MFN 07-593, Supplement 1

Subject: **Response to Portion of NRC Request for Additional Information Letter No. 103 Related to ESBWR Design Certification Application - Heating, Ventilation, and Air Conditioning - RAI Number 9.4-48**

RAI Number 9.4-48

Figure 9.4-12 Electrical Building HVAC System

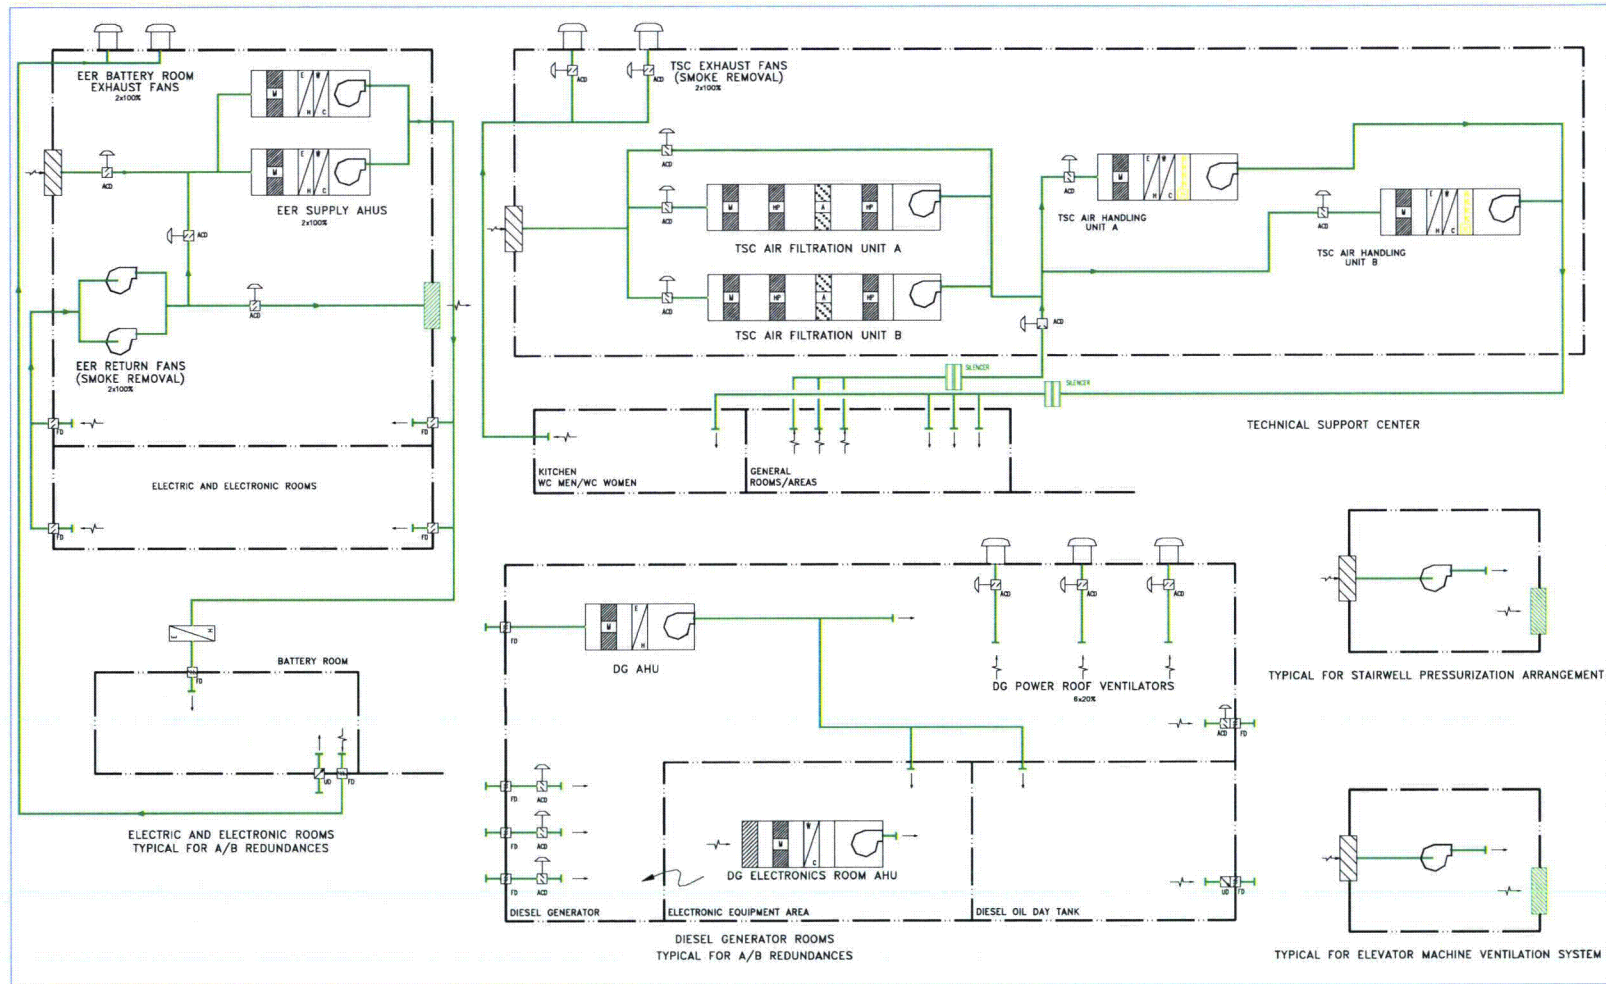
Identify the outside air intake and flow rate on Figure 9.4-12 for the EER or the Electrical Building Technical Support Center HVAC Subsystem (TSCVS) systems and discuss its adequacy in the DCD Tier 2 text. Has the potential effect of hot air being introduced from the outside been taken into consideration with the sizing of cooling coil capacity? Provide a table that shows the major components of the electrical building HVAC System (EBVS) including sub systems and basic design features including flow rates.

The EERVS and TSCVS air inlet louvers are shown on Figure 9.4-12 and are being changed to show them more clearly. The flow rates for EBVS subsystems are listed in Table 9.4-16. DCD Tier 2, Revision 4, has been updated to include a better description of the EBVS. The EBVS has been designed to meet 1% exceedance values, which includes hot air introduction from the outside.

DCD Tier 2 Figure 9.4-12 will be revised in Revision 5, to more clearly show the Electrical Building inlet louvers, as indicated on the attached markup.
